**AMENDMENT NO. 7-A (AMENDED)
TO THE
PROFESSIONAL ARCHITECT/ENGINEERING SERVICES
AGREEMENT
BETWEEN
THE TEXAS FACILITIES COMMISSION
AND
JACOBS ENGINEERING GROUP INC.**

**Subject: Additional Service Proposal – ASP 07
HHSC and TFC IT and Security Modifications; E. Guadalupe Sidewalk
Replacement; and, HHSC Conference Room Repurposing**

**Project: North Austin Complex
TFC Contract No.: 17-025-000**

Project: TELEROOM ROOM DETAILS - OFFICE COMPLEX - COMMUNICATIONS
 Sheet: 6 of 6
 Date: 1/4-001

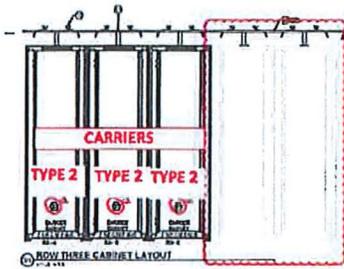
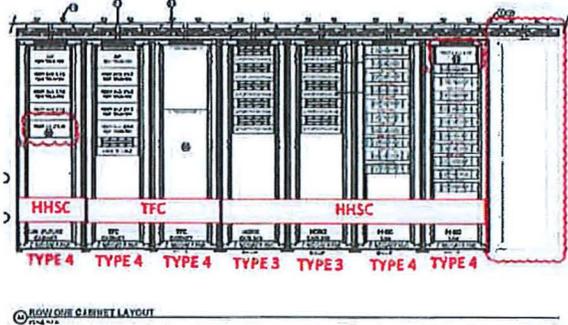
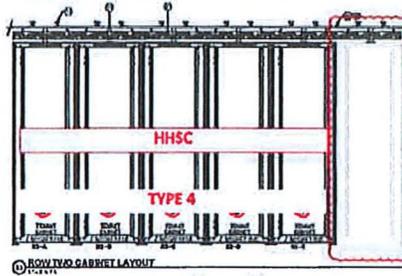
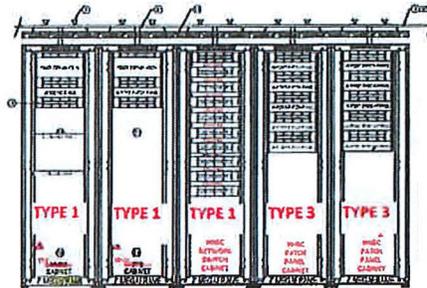
MDF ROOM 1.051

COLO ROOM 1.050

◀ TYPICAL ALL IDF ROOMS (LEVEL 1 NORTH TELECOM ROOMS, LEVEL 2-9 NORTH AND SOUTH TELECOM ROOMS)

TYPE 2
Carrier Cabinet
ALL CABINETS IN THE MDF (TELECOM ROOM 1.051)

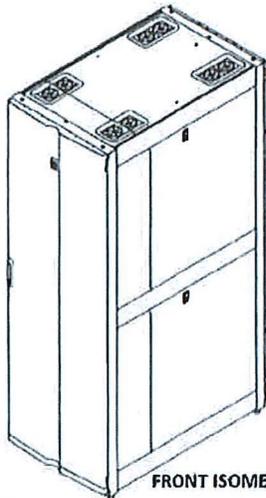
REMOVE PDUS FROM THESE CABINETS

In lieu of finger management, provide D-Ring in cabinets. CMPHHF1+CMPHH2 for these. 18ct 1RU managers and N-1B 2RU managers (N being number of switches.) The number of switches will be 98.

- (2) ~~SHORT FINGER MANAGER WITH NO DOOR~~ -INSTALL: FRONT LEFT RAIL-FRONT RIGHT RAIL
- (2) SINGLE FULL HEIGHT PDU BRACKET, 2.2 IN WIDE -INSTALL: REAR LEFT-REAR RIGHT

- ~~(1) 1 150C2 VERTICAL ECONNECT BASIC PDU WITH LC 20P INPUT PLUG AND LOCKING OUTLETS, IEC 320 C13(14) IEC 320 C15(16), BREAKERS (1 X 2P-20A) -INSTALL LEFT~~

- ~~(1) 1 150C2 VERTICAL ECONNECT BASIC PDU WITH LC 20P INPUT PLUG AND LOCKING OUTLETS, IEC 320 C13(14) IEC 320 C15(16), BREAKERS (1 X 2P-20A) -INSTALL RIGHT~~

TYPE 3 (PATCH)
~~Standard Cabinet~~
THESE ARE LOCATED IN THE COLO (ROOM 1.050), THE LEVEL 1 NORTH TELECOM ROOM AND ALL THE LEVEL 2-9 TELECOM ROOMS

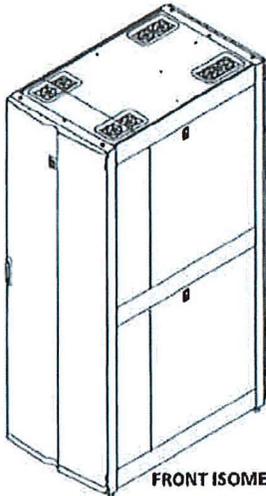
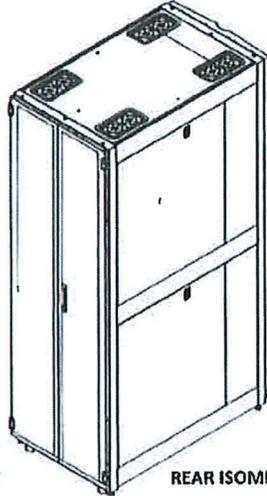
In lieu of finger management, provide D-Ring in cabinets. CMPHHF1+CMPHH2 for these. 18ct 1RU managers and N-18 2RU managers (N being number of switches.) The number of switches will be 98.

HORIZONTAL CABLE MANAGERS SHOWN ON THE ATTACHED ELEVATIONS TO BE PROVIDED BY WALKER

~~TFC/HHSC Cabinet~~
THESE ARE LOCATED IN THE LEVEL 1 COLO ROOM 1.050

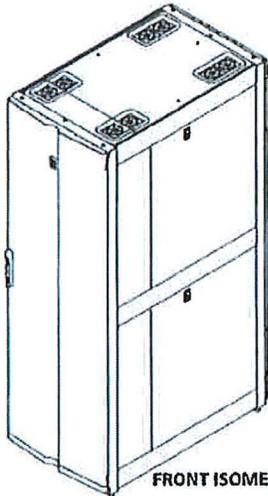
In lieu of finger management, provide D-Ring in cabinets. CMPHF1+CMPHH2 for these. 18ct 1RU managers and N-18 2RU managers (N being number of switches.) The number of switches will be 98.

- STANDARD SOLID SIDE PANEL - INSTALL RIGHT
- ADJUSTABLE AIR DAM KIT FOR USE WITHOUT FULL-DEPTH BOTTOM PANEL
- (2) ~~SHORT FINGER MANAGER WITH NO DOOR~~ - INSTALL: FRONT LEFT RAIL - FRONT RIGHT RAIL

- (1) ~~P3-3DOAS~~ - VERTICAL ECONNECT MONITORED PDU WITH ^{LS-20P} ~~LS-30P~~ INPUT PLUG AND STANDARD OUTLETS: NEMA 5-15/5-20(24), BREAKERS (2 X 2P 20A) - INSTALL RIGHT
